ADA Curb Ramp New Construction Inspection Form (Parallel)

NW Main

23885.56

NW Lenox

PARALLEL RAMP (PL)

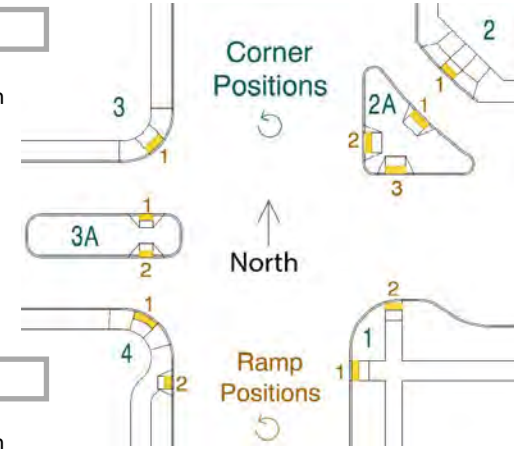
5.3 $\leq *$ ☐ $> *$ ☒

11.1 $\leq 8.3\%$ ☐ $> 8.3\%$ ☒

DWS IITD Fails RR 1
